Whitworth Street Planning Comparison

Since planning approval in 2016 the site has been purchased by Vision Manchester Limited. The client has engaged a full design team and RussellWBHO to update the detail design to the required regulations, agree a building contract and construct the development. Through this process a number of design changes are being proposed.

This updated document is being presented to Manchester City Council Planning Department to illustrate and explain the nature and extent of the proposed changes and to seek the Council's formal approval through the necessary planning process.

3.20 Proposed Elevation North

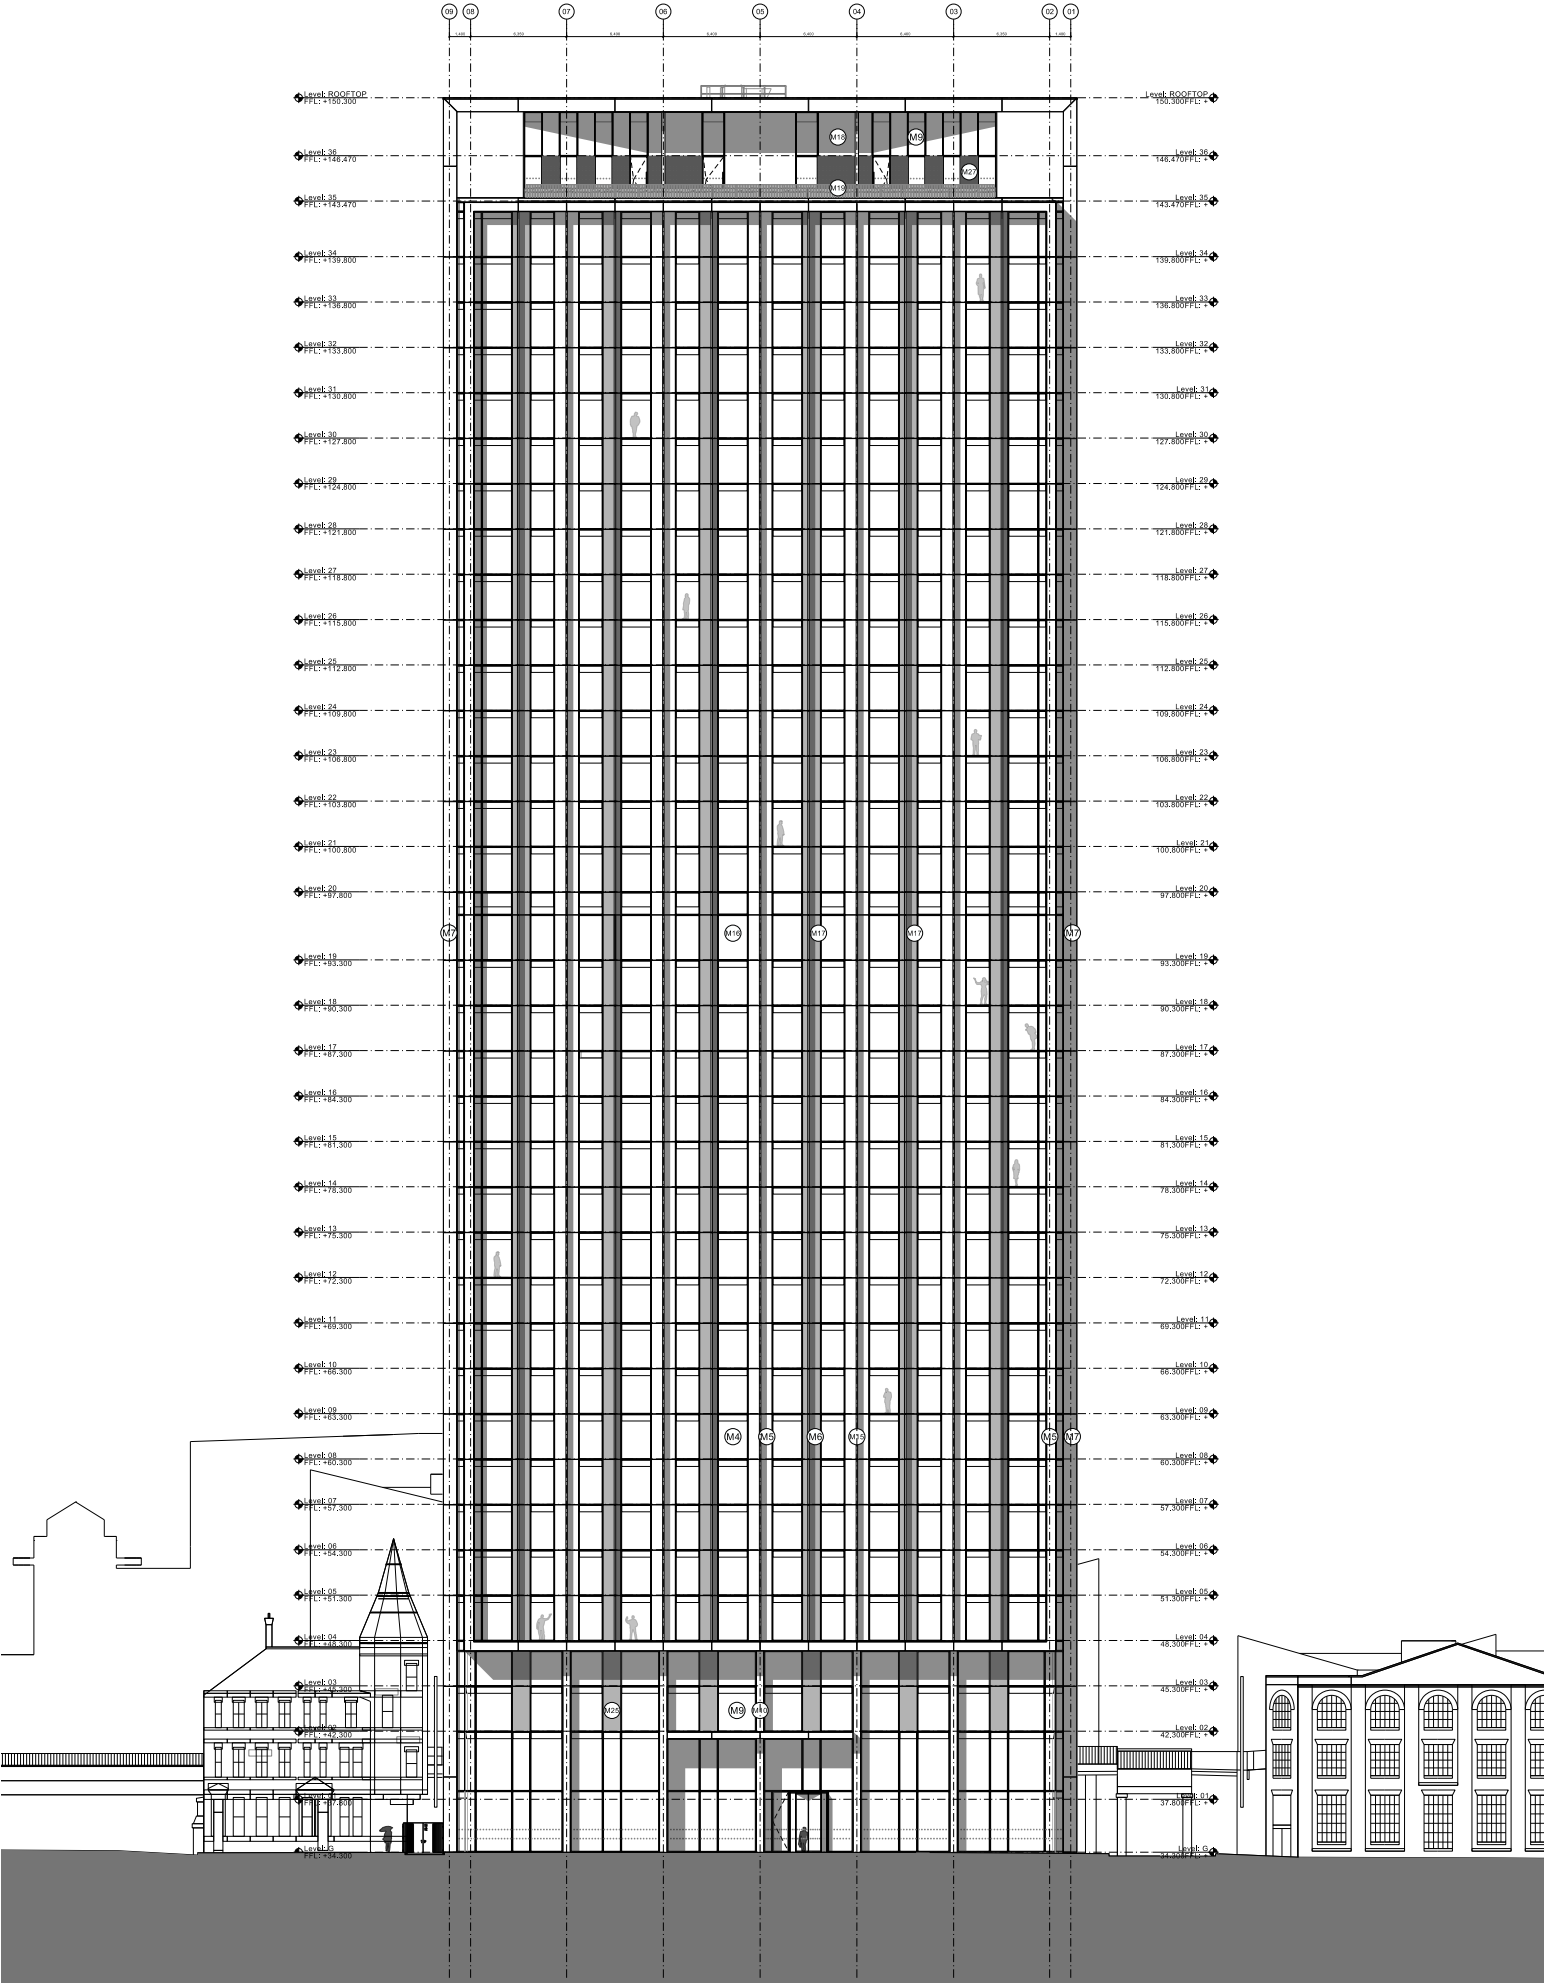
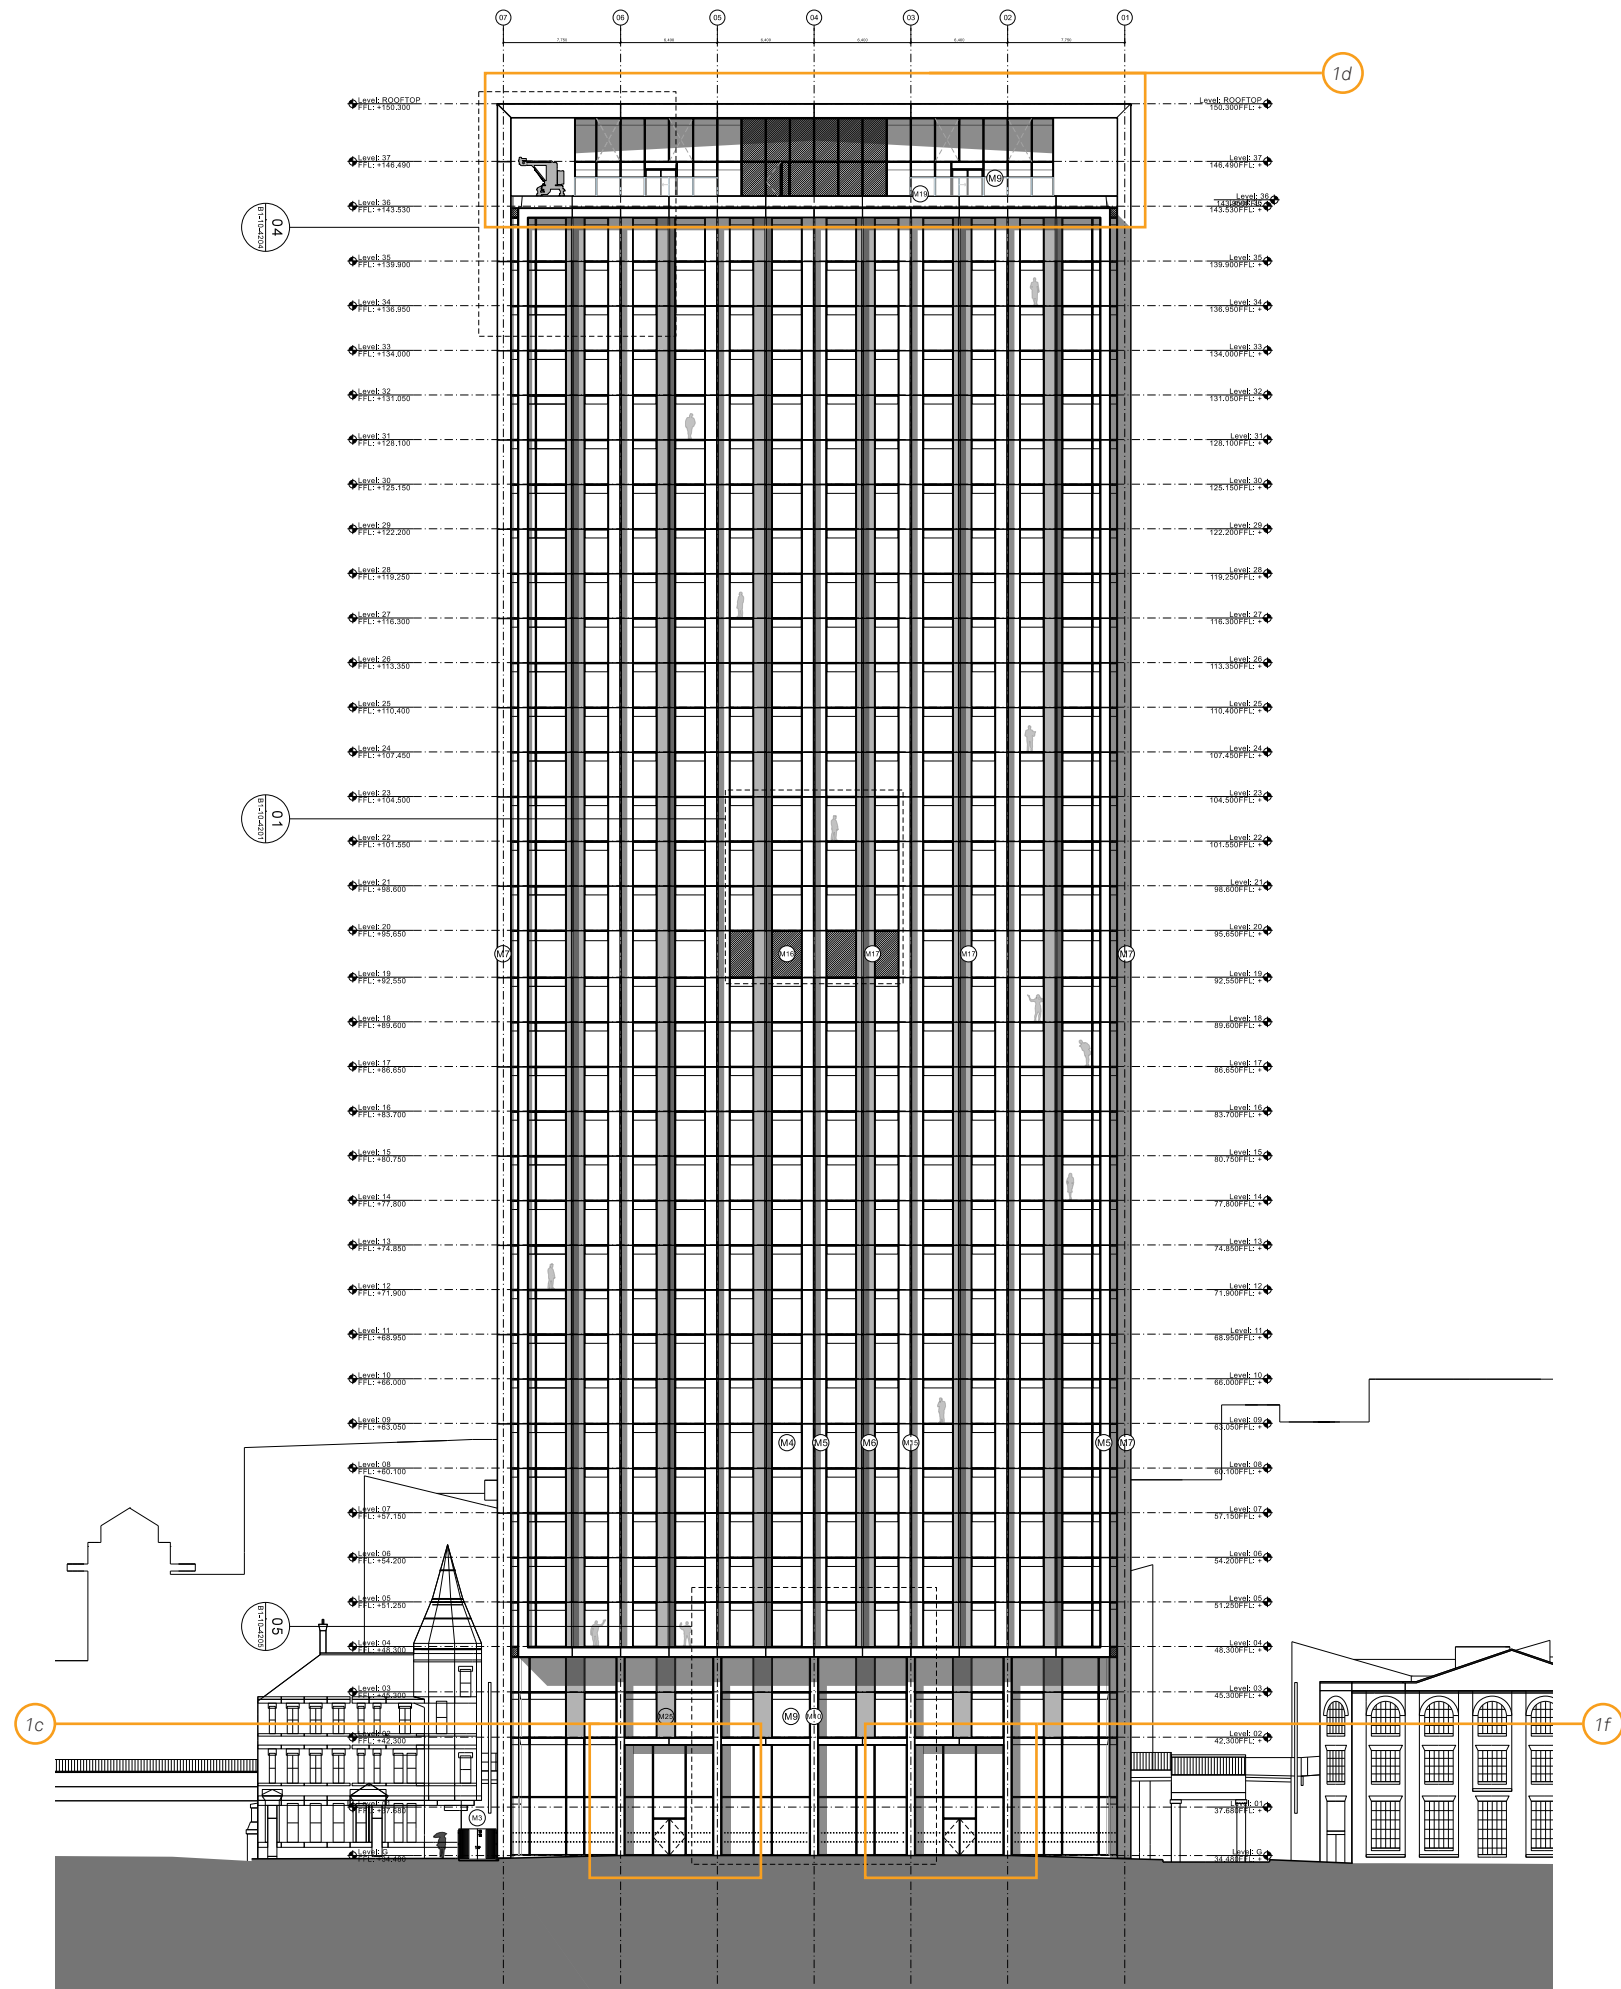
- 1a - Core Repositioned
- 1b - Main body of south facade to match north facade
- 1c - Entrance relocation
- 1d - Form of roof pavilion
- 1e - Apartment & amenity layouts
- 1f - Inclusion of commercial unit & dedicated entrance
- 2a - Reduced floor to floor heights
- 2b - Additional floor
- 2c - 2 no. Guest Beds & 2 no. 1 Bed become 2 no. 2 Bed & 2 no. 3 Bed
- 3 - South 'picture frame' reveal depth reduced by 600mm
